ADDENDUM TRAFFIC IMPACT STUDY

**SECTION OF LOTS 7,8 AND 9, CONCESSION 10
TOWNSHIP OF PUSLINCH
COUNTY OF WELLINGTON**

CFCA FILE NO. 2433-6646

D14-KUK – 4th Submission Comment Summary

Conceptual Plan
44 Lots
 PART OF LOTS 7, 8, & 9, CONCESSION 10
 ASSESSMENT ROLL NUMBER 2301000008034800000
 ARKELL, ONTARIO

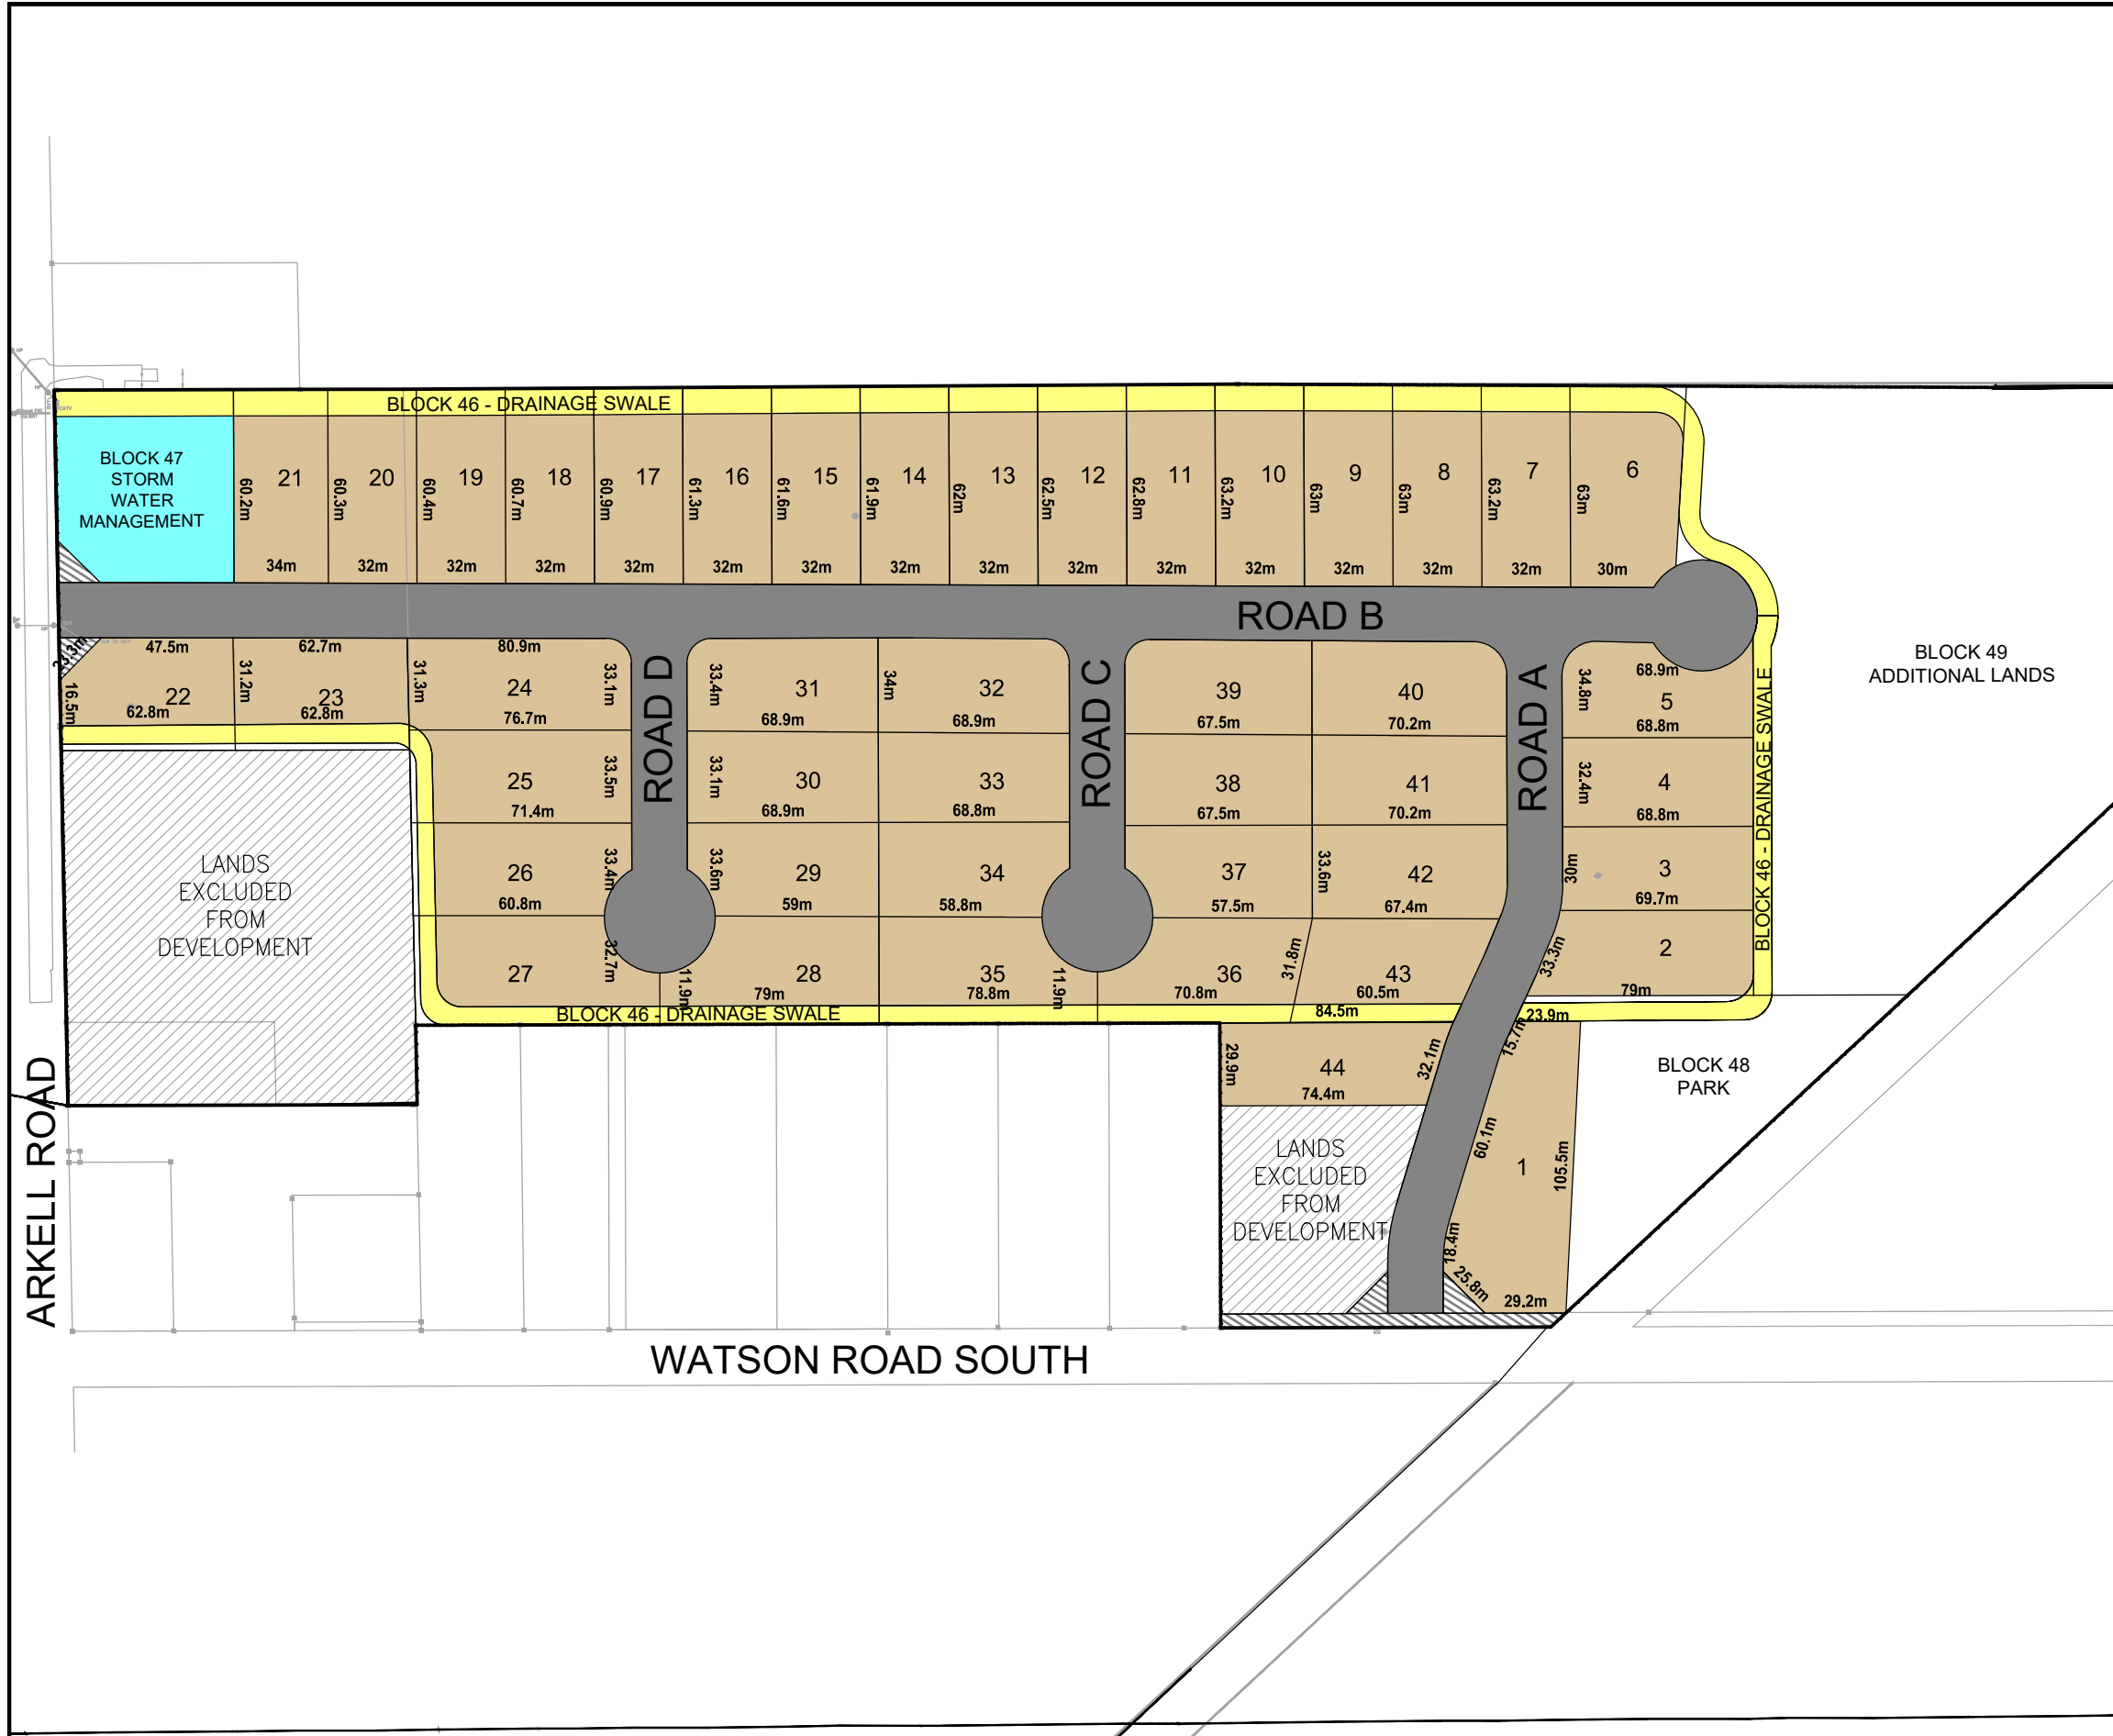
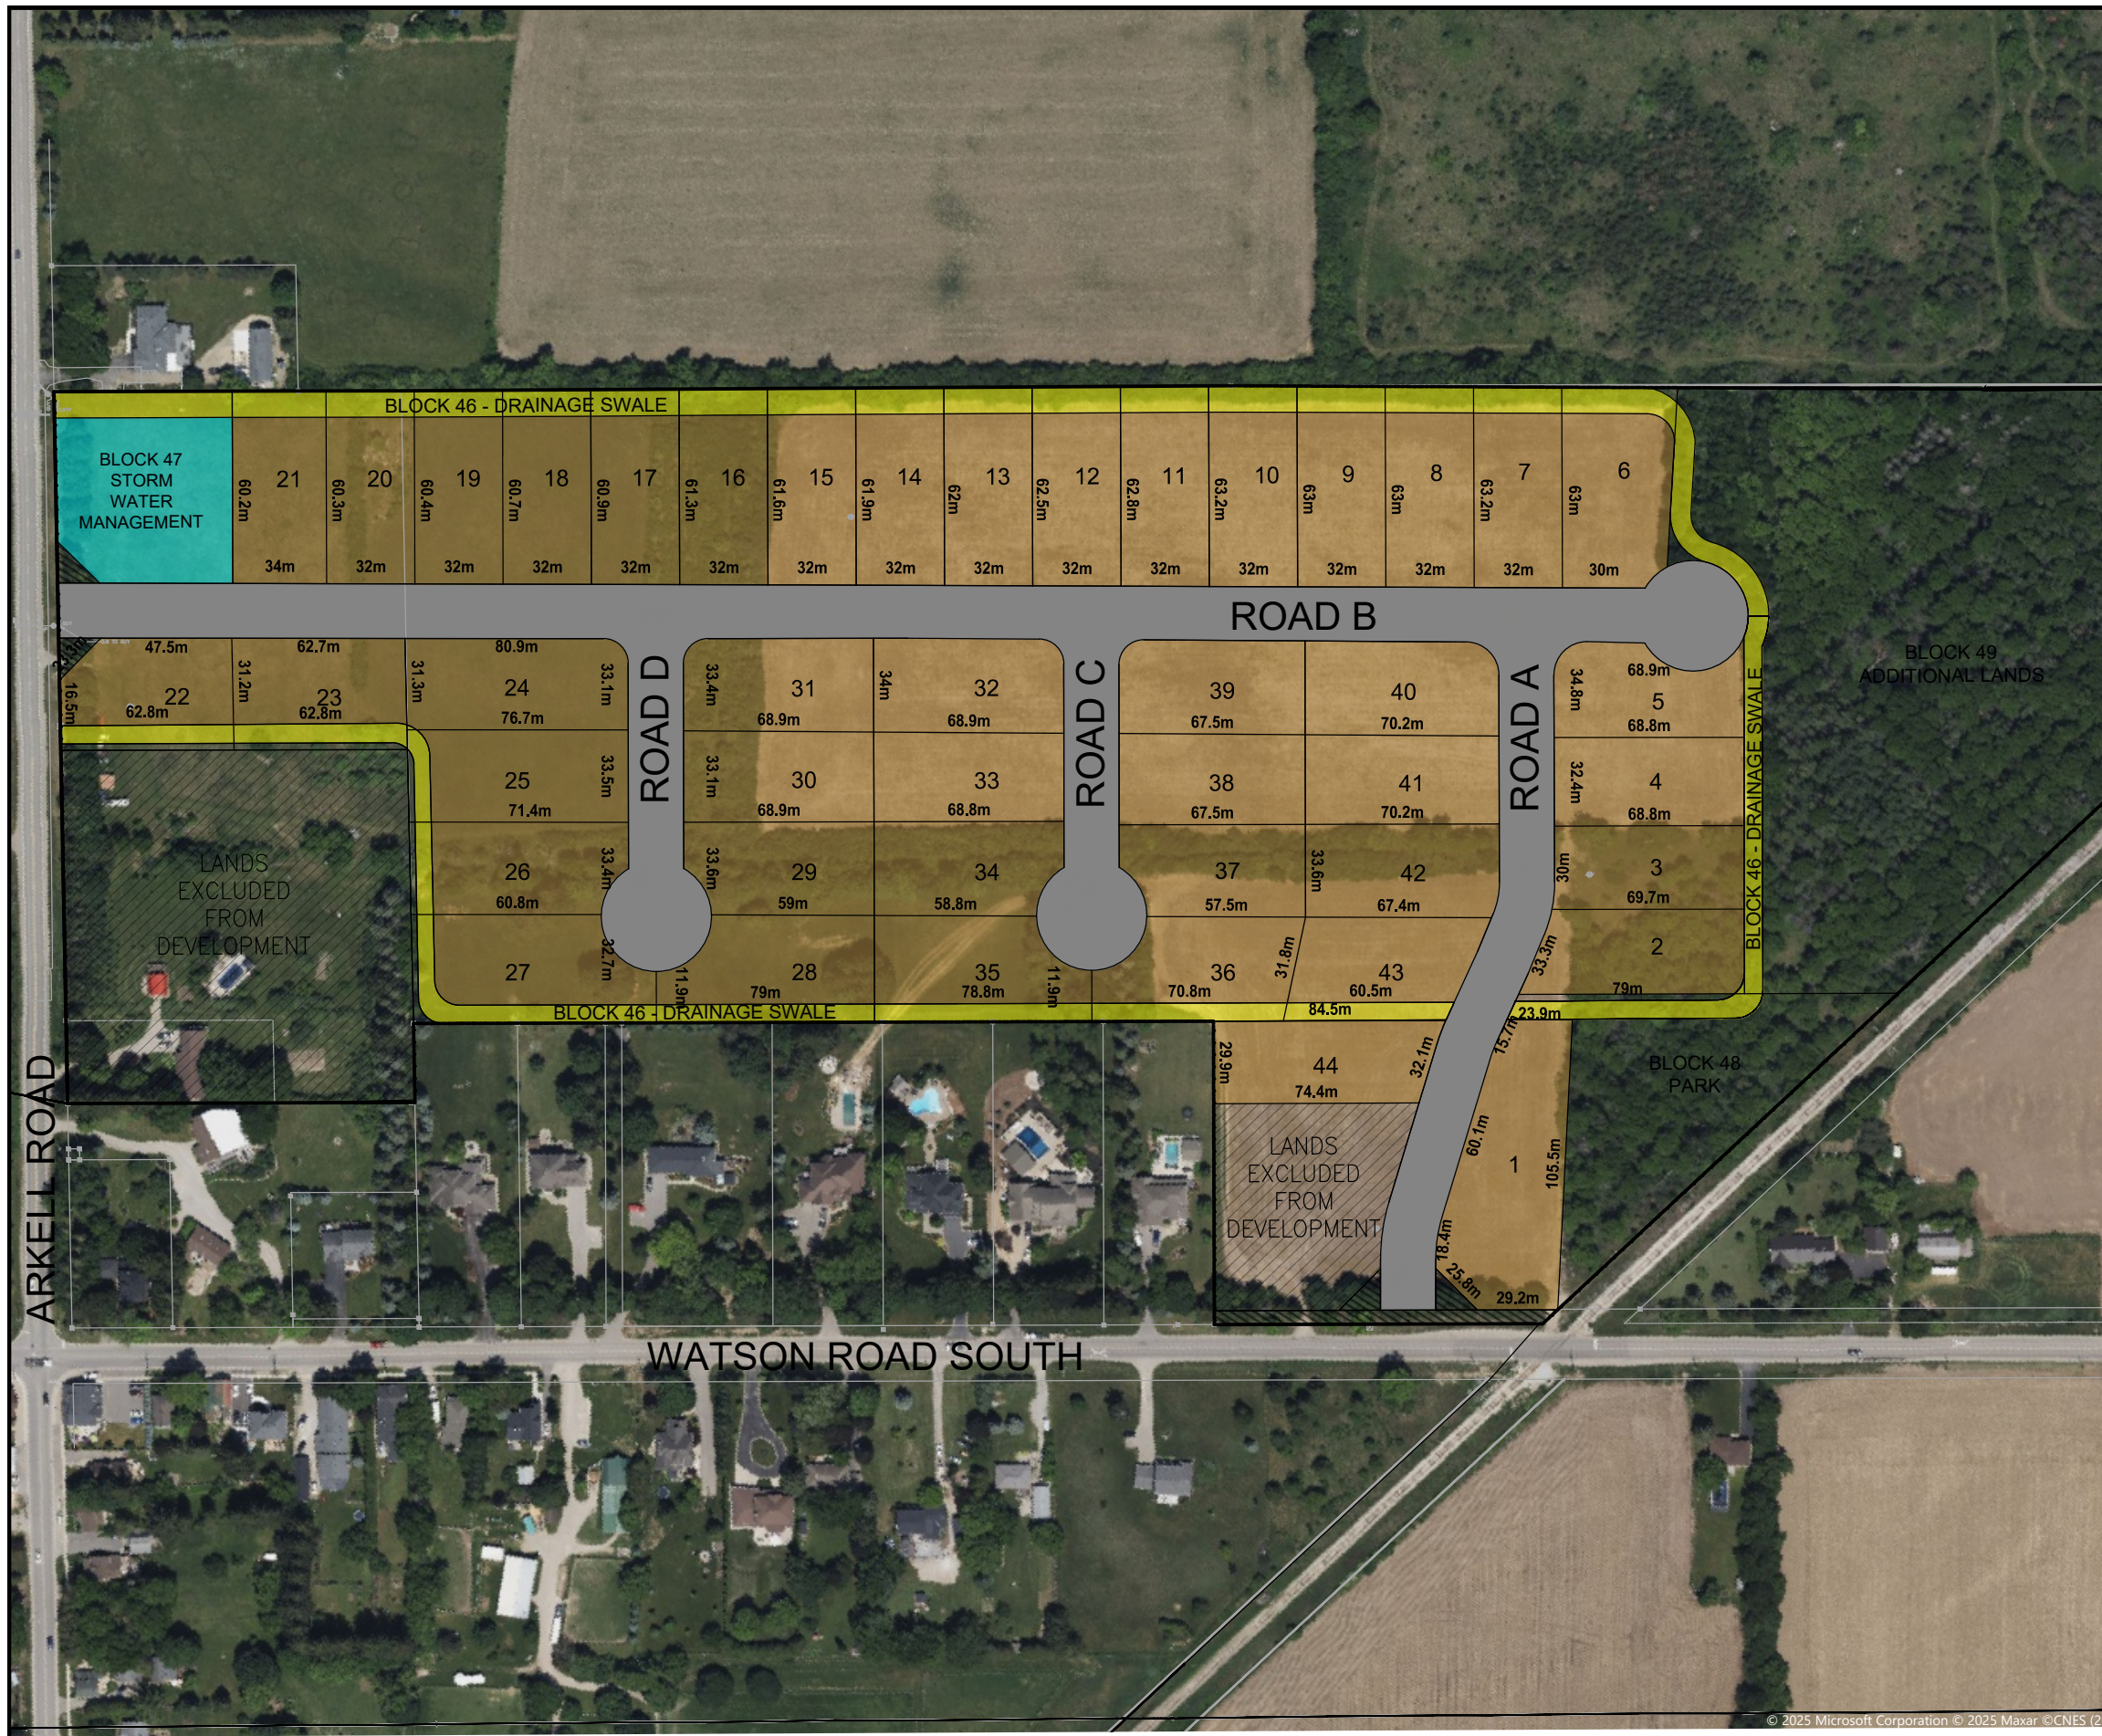
Township of Puslinch	C.F. Crozier & Associates Inc. Comment Responses
Traffic	
<p>- The TIS continues to say that the proposed road connection to Arkell Road is for emergency purposes, but the site concept plan that was included with the application appears to include a fully open public road connection. As Arkell Road is a Wellington County Road, I will defer to the County to comment on the proposed road connection. The addition of a second road connection for the subdivision would result in more routing options for traffic and less traffic at the Watson Road South connection near the railway and reduced impacts on any one traffic movement at the Watson/Arkell intersection.</p>	<p>Noted. The Addendum TIS has assessed the impact of the proposed development on the boundary road network under the assumption that the site will be served by two access connections, one to Watson Road South and the other to Arkell Road.</p>

<p>- The study maintains analysis for 50 units when 44 are now proposed. A reduction in the number of units would result in fewer trips on the road network so the current analysis is conservative.</p>	<p>Noted. The addendum TIS maintains the trip generation based on an older site plan which had 50 residential properties. It's noted that this was conservatively maintained as no material change in transportation operations or recommendations is expected.</p>
<p>- The TIS indicates that the sight distance assessment was based on a review of base mapping and aerial mapping. The aerial mapping in the TIS illustrates the available sight distance in plan view, but does not confirm that there are no vertical curves in the road. Were vertical road plans reviewed to confirm the sight distance or did the consultant do a field visit to confirm? How was the available sight distance confirmed?</p>	<p>Noted. A field visit was conducted to confirm the adequacy of the available sightlines.</p> <p>The field visit confirmed the following:</p> <ul style="list-style-type: none"> • There were no visual obstructions along Arkell Road, with sight distances exceeding 190 meters to the right and 165 meters to the left. Given the design speed of 90 km/h, the minimum required sight distances are 165 meters for right turns and 190 meters for left turns. Since the available sight distances surpass these requirements in both directions, all safety standards are met and no concerns regarding site access are expected.
